**JSCC WORKFORCE DEVELOPMENT BUILDING  
SCO # 22-24540-02A**

**CMAR ADDENDUM NO. 3 (CM3)**

ISSUED ON: FEBRUARY 19, 2025

## Monteith Construction RFI Log

Sheet No.
S4.12 Addendum 5, Attachment 3

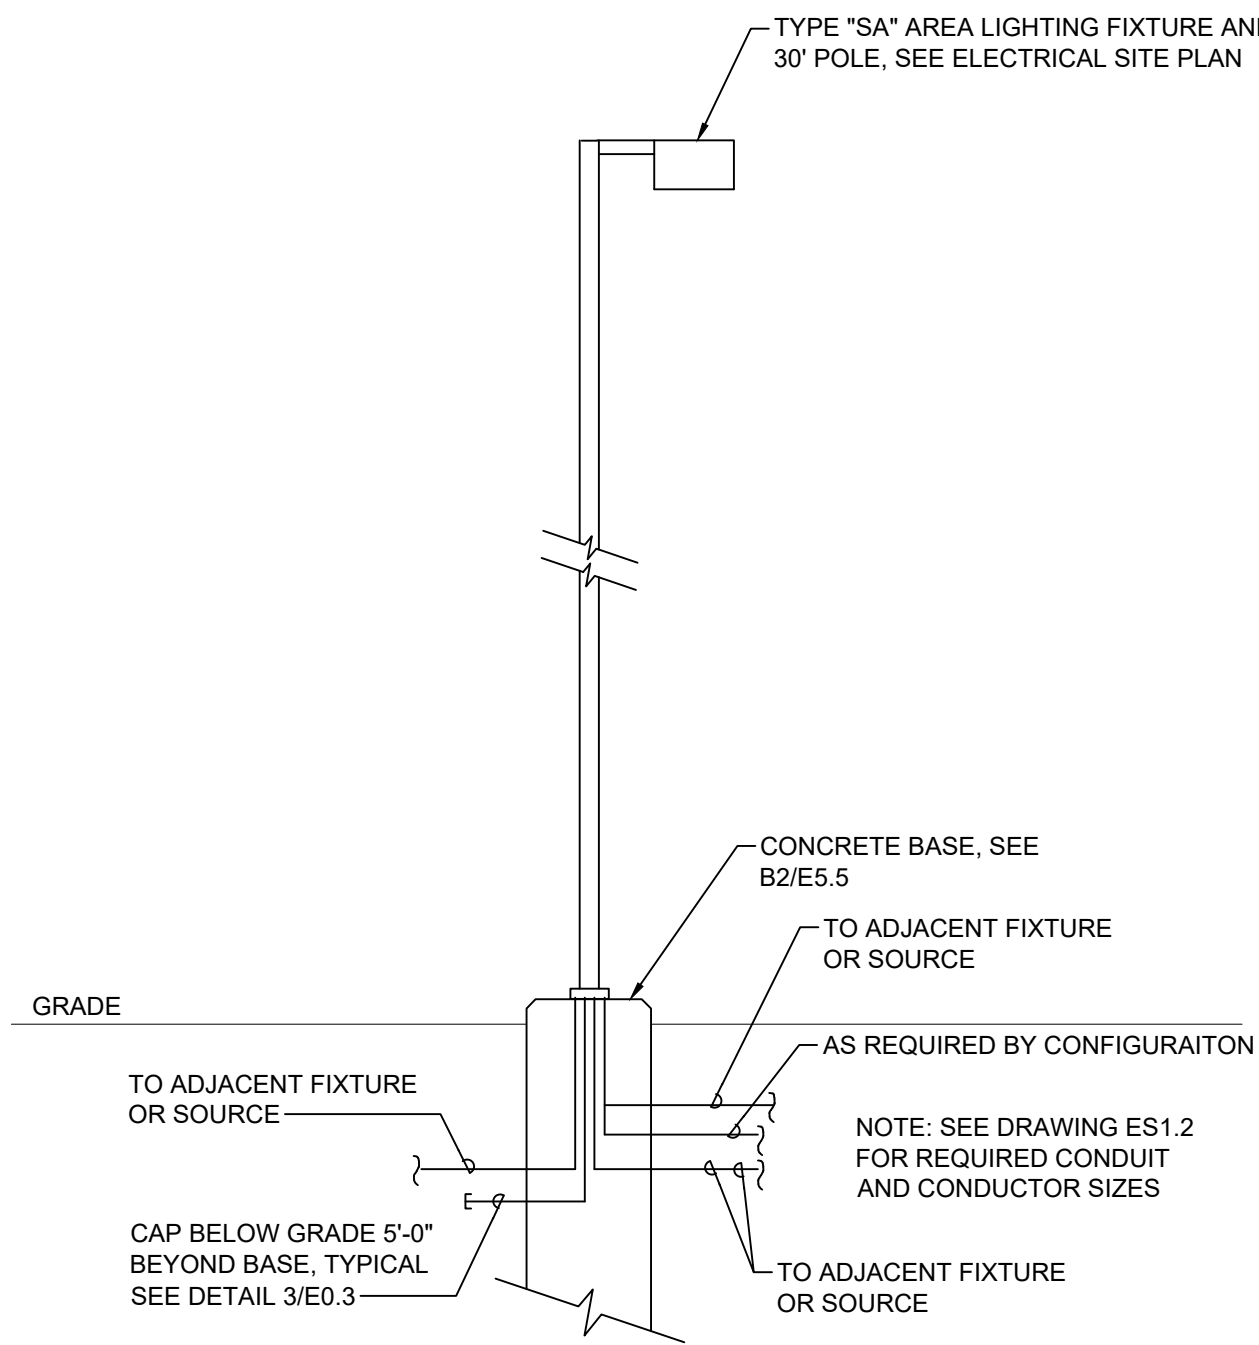
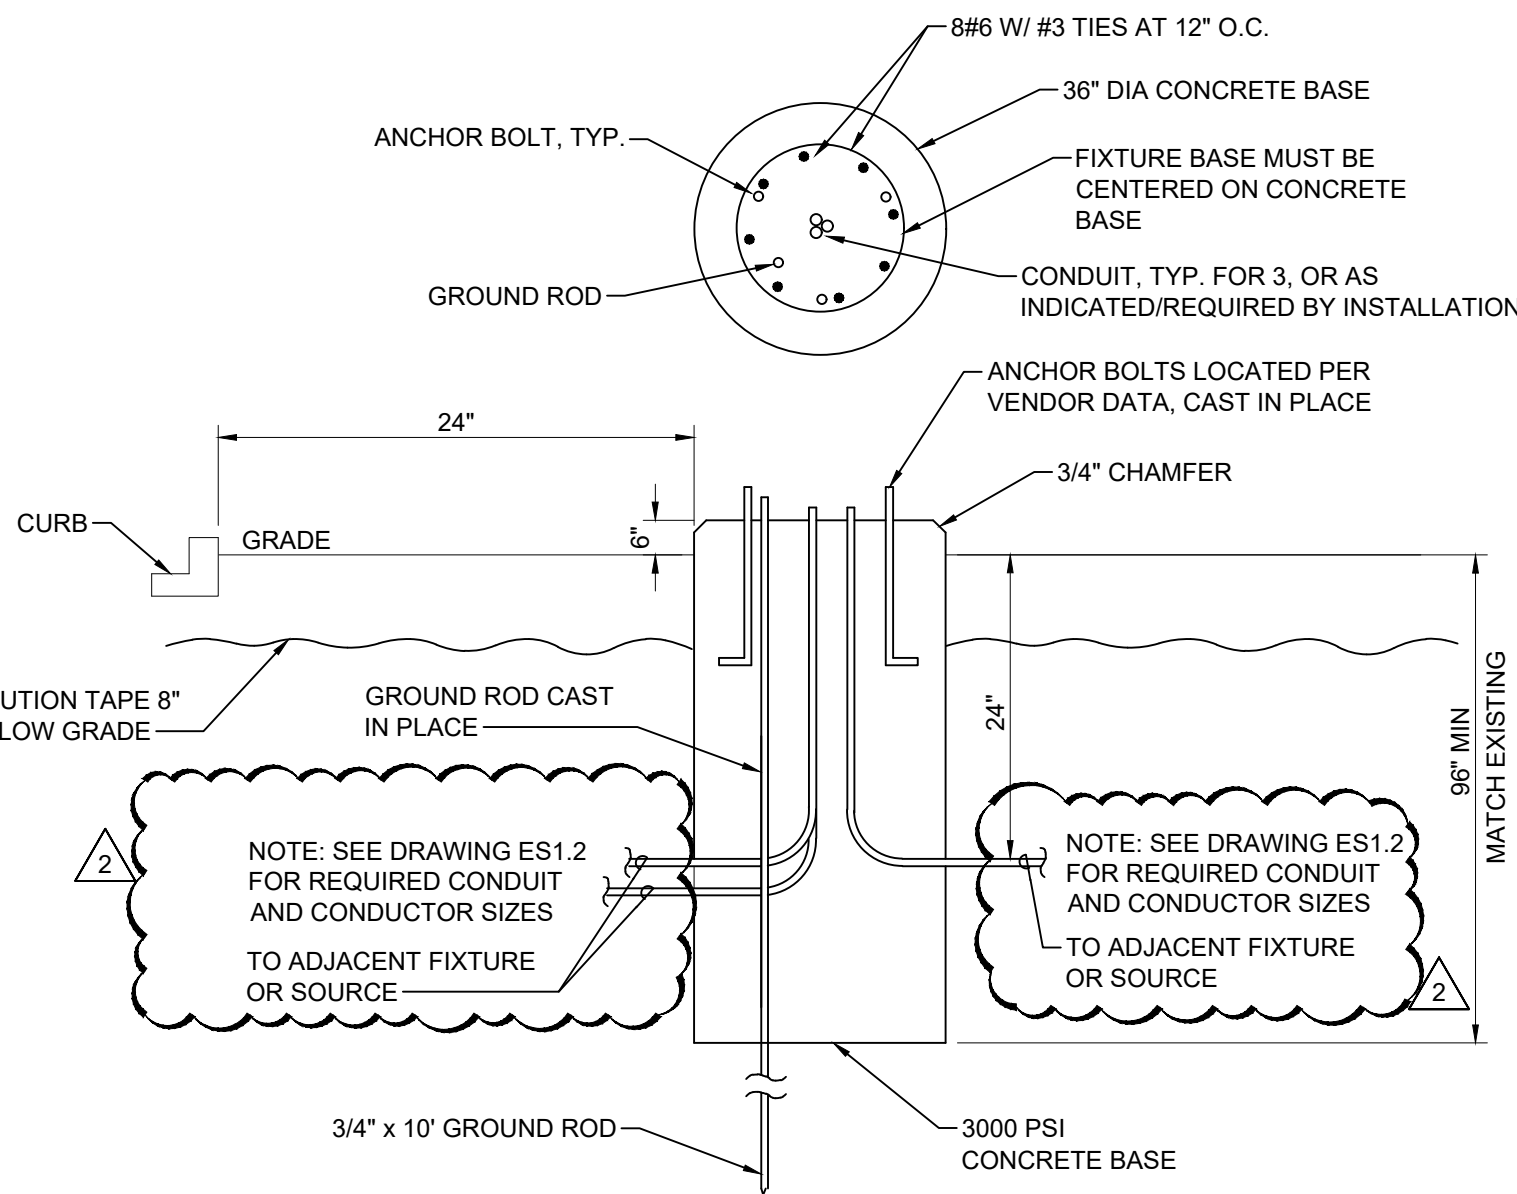
**Item 13                    Drawings S2.02, S2.03, and S4.12 - Revisions (RFI #44)**

Request for Information was submitted on the brick masonry shown in building section 2/A4.1 on column lines 6 and 7. Structural Drawings S2.02 Low Roof Framing Plan, S2.03 Roof Framing Plan, and S4.12 Framing Sections and Details have been revised to include steel supports and structural detailing at these locations. Revised drawing sheets S2.02, S2.03, and S4.12 are included as **Attachment #3**.

**B2 TYPE "SA" AND "SA1" AREA LIGHTING FIXTURE CONCRETE BASE DETAIL**  
NOT TO SCALE

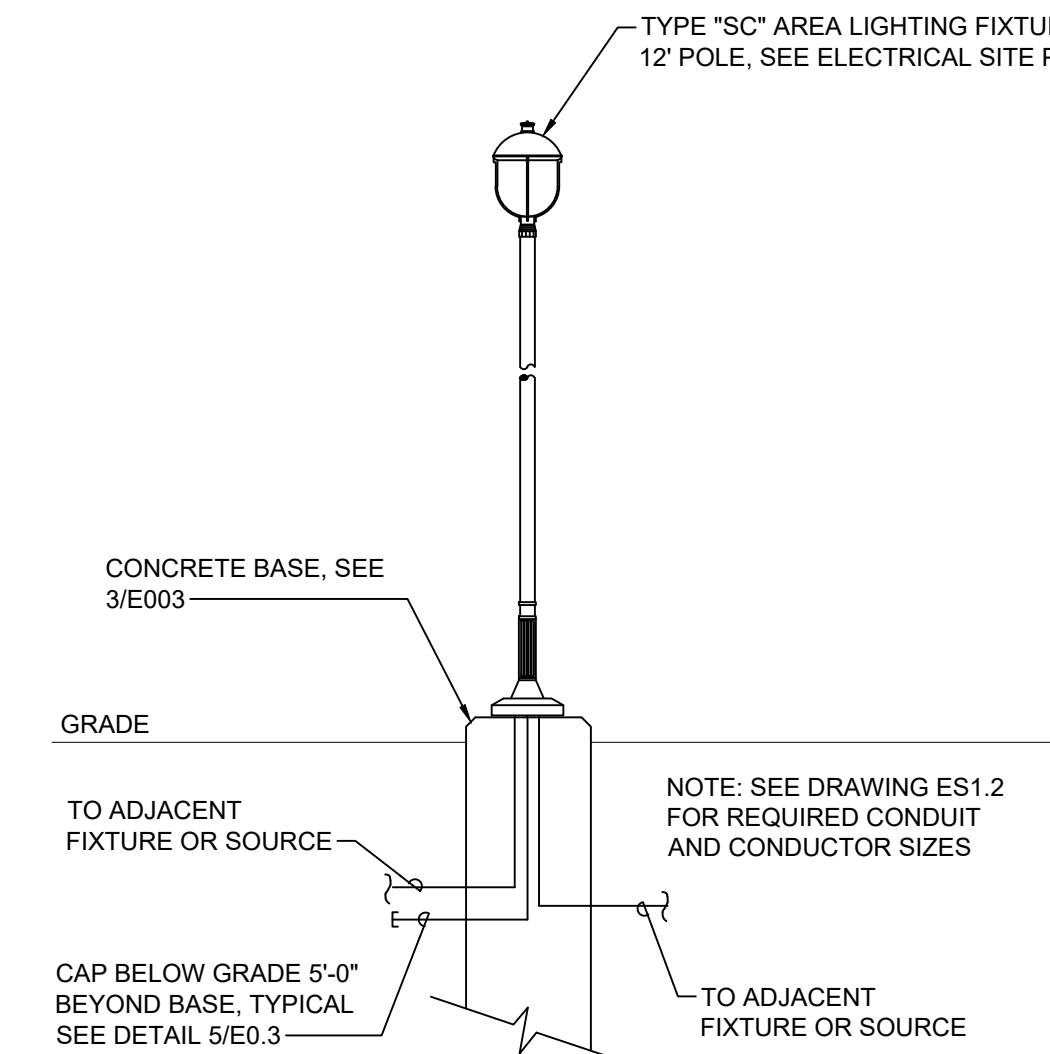
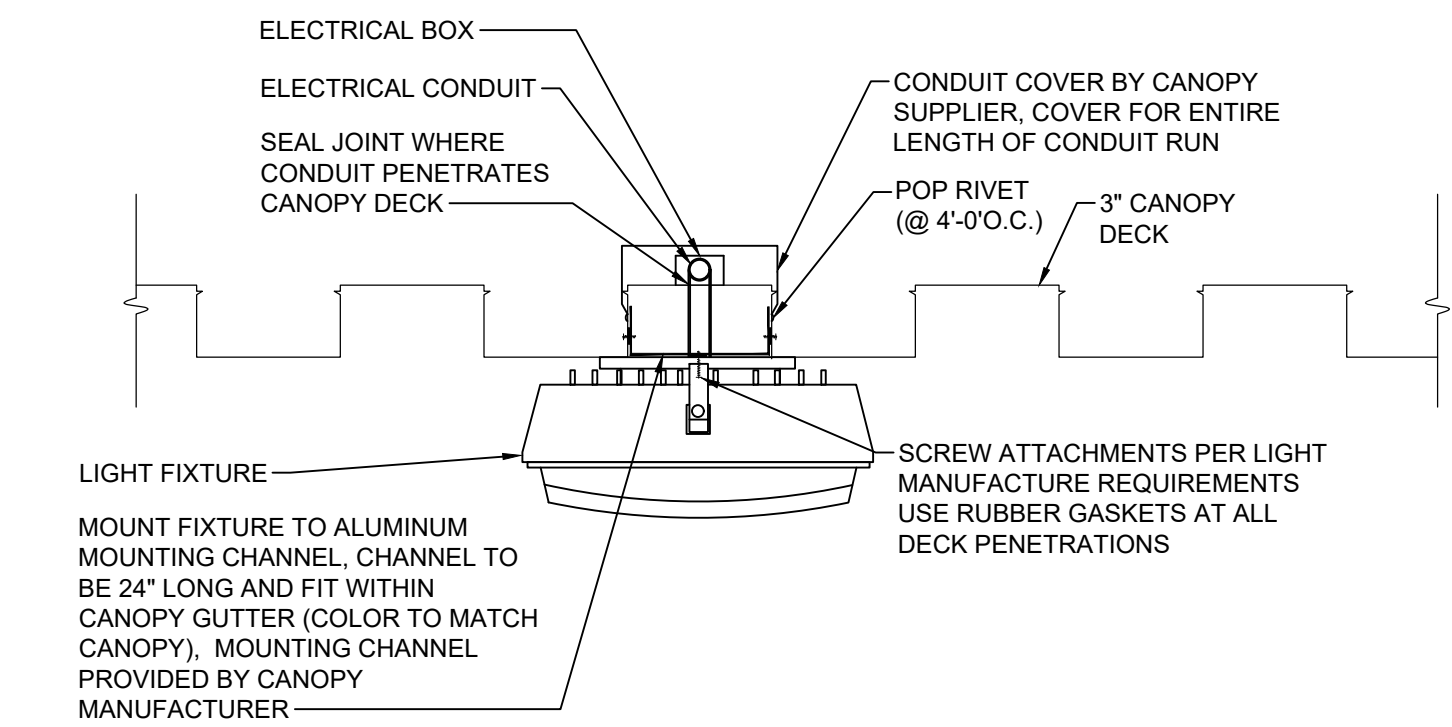
**Item 14                    Drawing E5.5 - Revision (RFI #45)**

**Item 15                    Drawing E5.5 - Revision (RFI #46)**

Clarification regarding circuits for site lighting: Direct buried conductors have been removed from Drawing E5.5 details B2 & D2. Refer to sheet ES1.2 for site lighting conduit and conductor sizes. Revised drawing sheet E5.5 is included as **Attachment #4**.

Conduit sizes have been removed from drawing sheet E5.5 details B2 & D2, see drawing ES1.2 for conduit and conductor sizes. Revised drawing sheet E5.5 is included as **Attachment #4**.
